STATE OF WASHINGTON
DEPARTMENT OF ECOLOGY

September 10, 2009

Re: Further Action at the following Site:

- **Site Name:** Mowhawk Flush Doors (also, Seattle Door, SEEDORCO, Sauder Door, Premdor)
- **Site Address:** 747, 777, and 787 - 6th Street South (formerly 733 and 815), Kirkland, Washington
- **Facility/Site No.:** 98437118
- **VCP Project No.:** NW 1543

BASE MAP

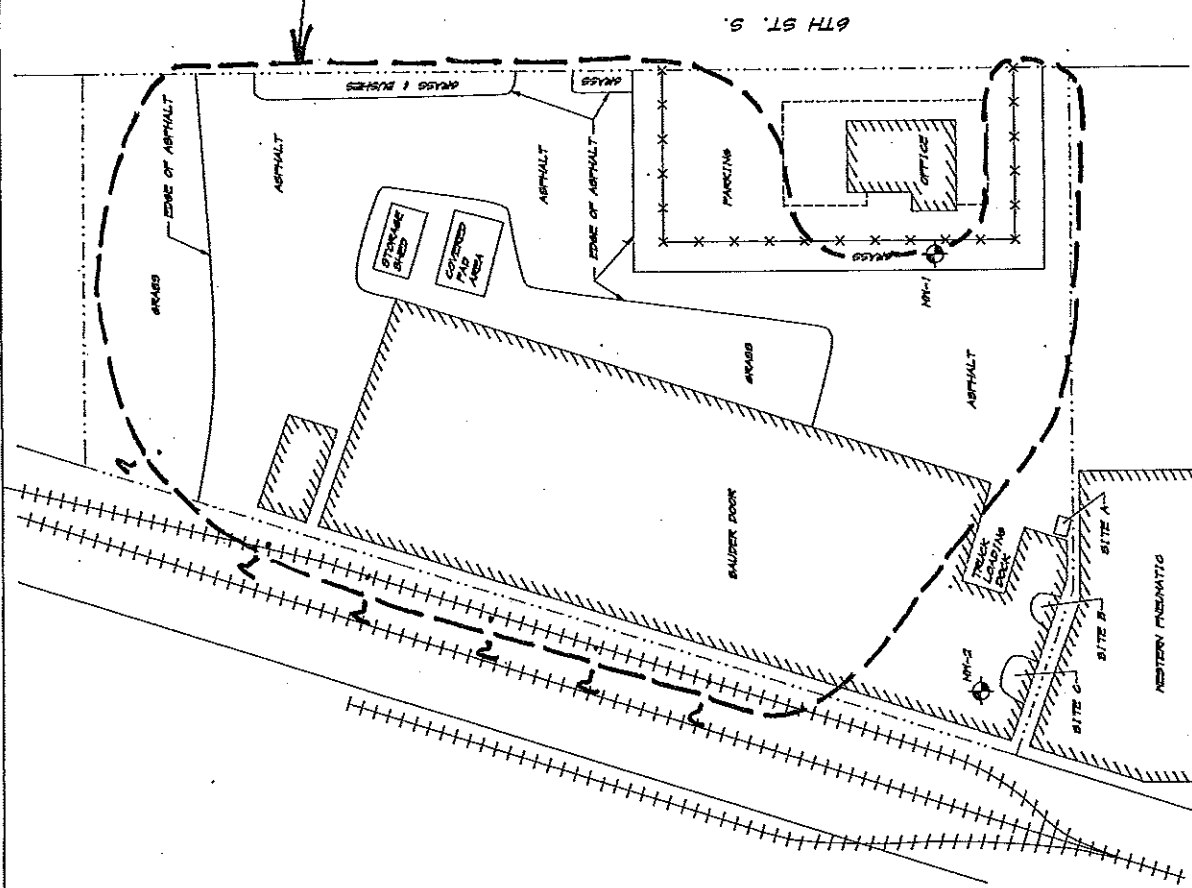
APPROXIMATE BOUNDARY
OF SITE
M. ADAMS, ECOLOGY
SEPT, 2009

Surface Soil
Sampling Locations

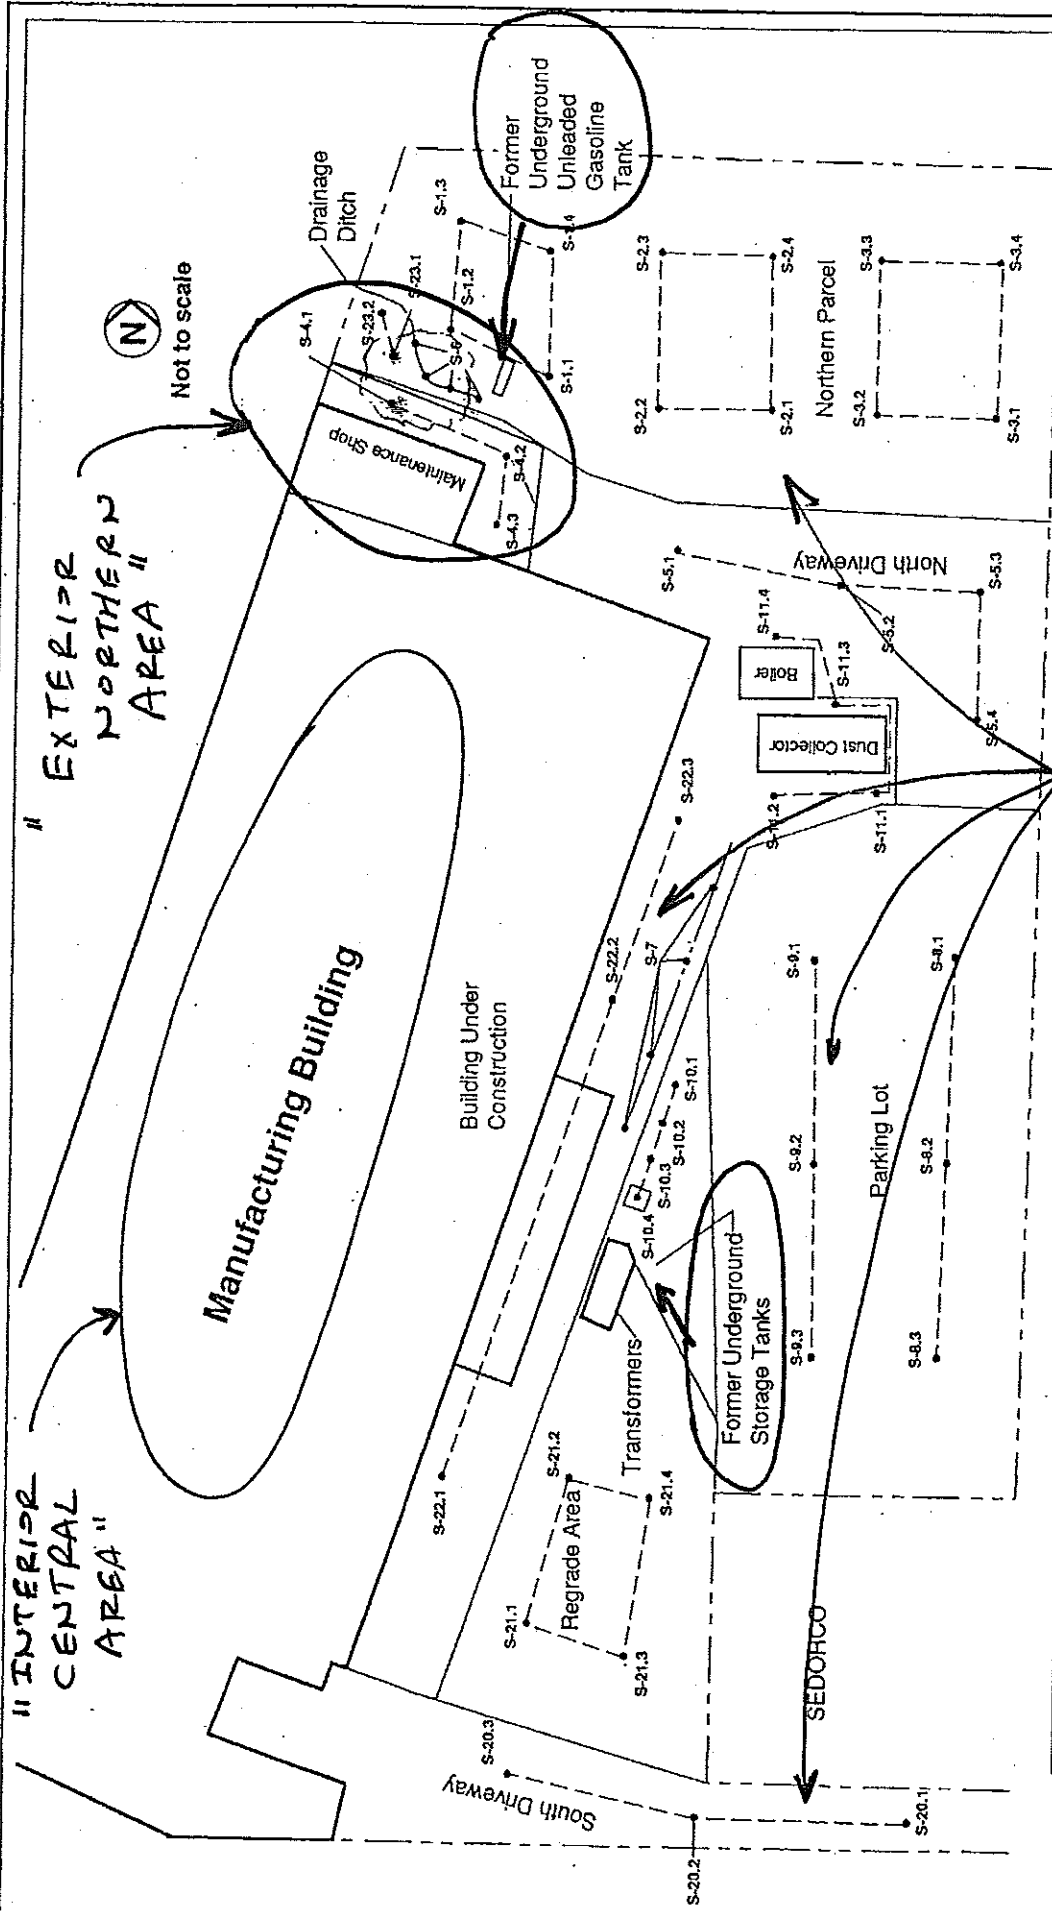
- Exterior Parking Lot Area: Initial sampling showed that shallow soils across much of the former parking areas contained PAHs and pentachlorophenol at concentrations below cleanup levels, except possibly at one location at the south driveway where total PAH concentrations were relatively high (3.2 mg/Kg) (see Enclosure A). Additional sampling was undertaken in the main parking lot, but not the south driveway area, and showed elevated concentrations of cPAHs and oil-range hydrocarbons. Further evaluation is needed of the potential for soil contamination to be present in the south driveway area, specifically near sample number S-20 (from Weston, August 1990).

- Exterior Parking Lot Area: Initial sampling showed that shallow soils across much of the former parking areas contained PAHs and pentachlorophenol at concentrations below cleanup levels, except possibly at one location at the south driveway where total PAH concentrations were relatively high (3.2 mg/Kg) (see Enclosure A). Anecdotal reports indicated that oil was spread in just a portion of the parking areas - the main parking lot in the central eastern portion of the Property. Additional sampling was therefore undertaken in the main parking lot, and showed elevated concentrations of cPAHs and oil-range hydrocarbons. Remediation of the main parking lot area therefore occurred in 2006 through excavation and removal of 12 to 18 inches of soil. Confirmation samples showed that cleanup levels had been achieved throughout this area.

INTERIOR CENTRAL CONFIRMATION	
FORMER SEATTLE DOOR PROPERTY 733 - 6th STREET SOUTH KIRKLAND, WASHINGTON	
Job No: 05182E	Date: Revised Sept. 2009
	Placer: 5

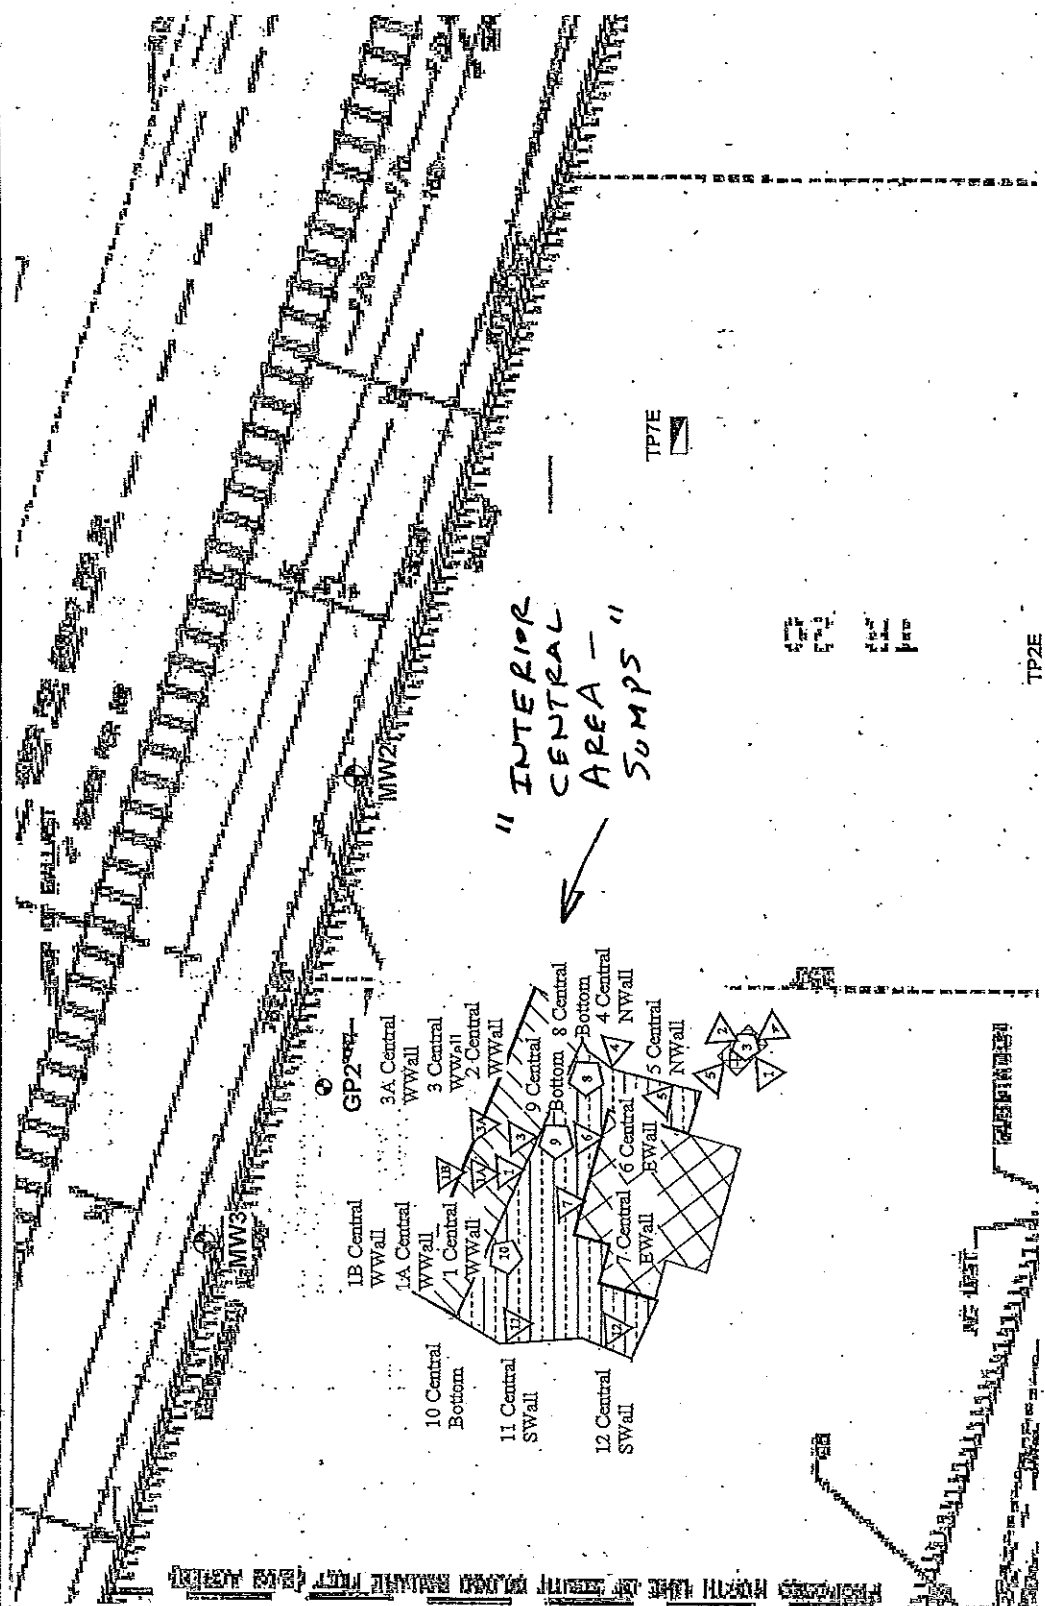
- The potential nature and extent of contamination associated with the "Interior Central Area – Another UST" (see Enclosure A) has not been determined in soil.

- **Interior Central Area – Sumps:** An interim cleanup occurred in this area in 1996, consisting of the excavation and removal of approximately 259 cubic yards of contaminated soil. Confirmation samples obtained at the time showed oil-range hydrocarbons remaining above the cleanup level on the northern and western edges of the excavation. Further excavation and removal occurred in 2006. Confirmation samples showed that remaining soils contained hydrocarbons at concentrations below the cleanup level.

- **Interior Central Area - Hydraulic Lift:** Oil-contaminated soils were located beneath the southern portion of the main building associated with a hydraulic lift sump. Up to 29,000 mg/kg of oil-range hydrocarbons were initially detected in soil in this area (testing via Method 418.1). The sump was excavated and associated contaminated soils were removed to a depth of 9 feet during the construction of the new buildings. Confirmation base and sidewall samples were obtained and showed no detectable TPH or PAHs.

- The potential impact of Site contamination on ground water needs further evaluation. Specifically, at least three ground water samples are needed from either "geoprobes" or monitoring wells located along the western edge of the Property.
